IN HOUSE REJECTION: KAIZEN

4b.3 STRENGTH

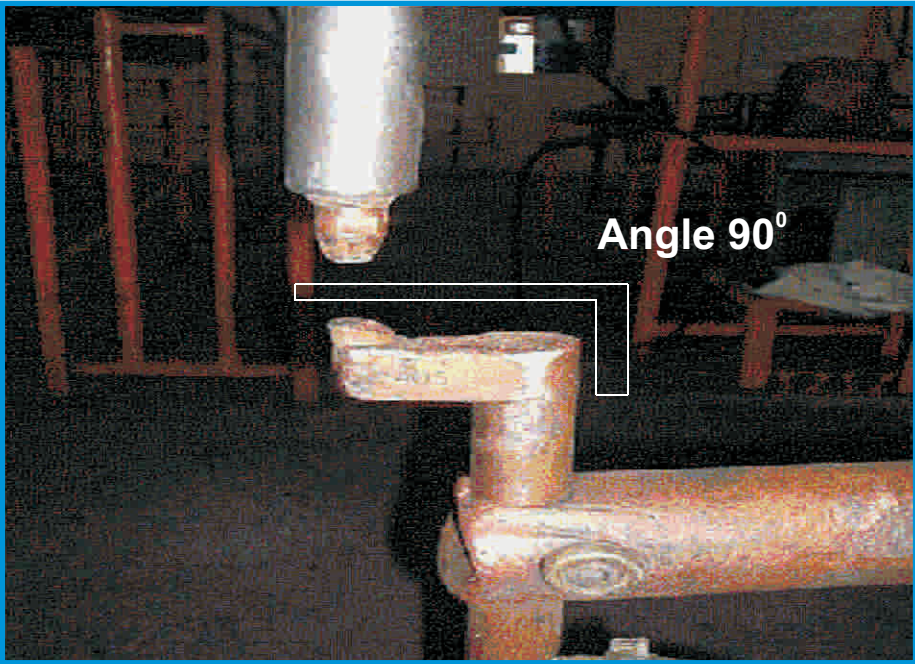
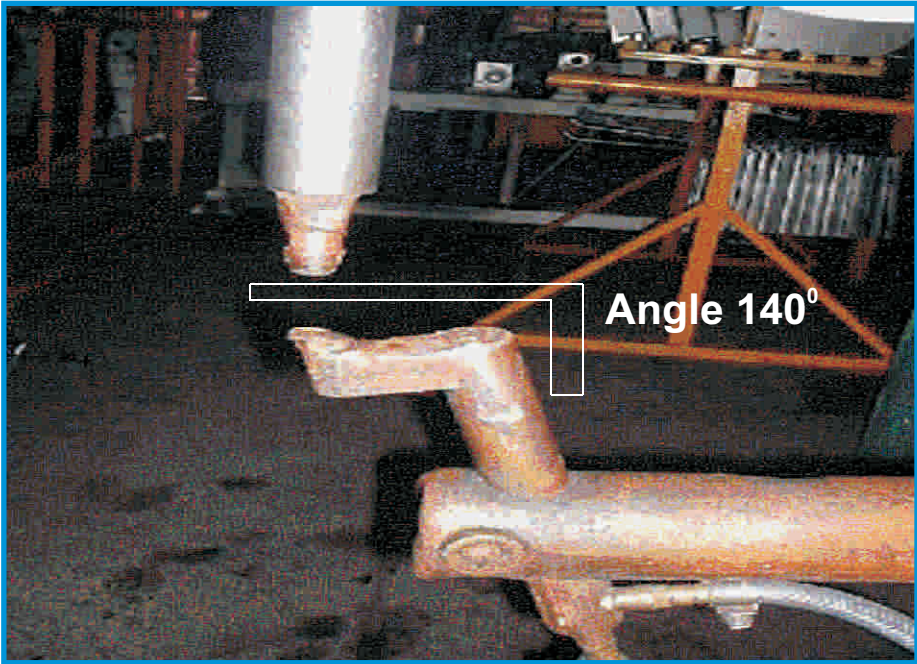
Physical Phenomenon : **Spot weak**
Due to : Man / **Machine** / Method / Material

Current bypass as part touch to holder

Root Cause : Electrode holder touches part.

Kaizen Idea : Electrode holder not to touch part

Kaizen : Electrode holder change to 90 deg.
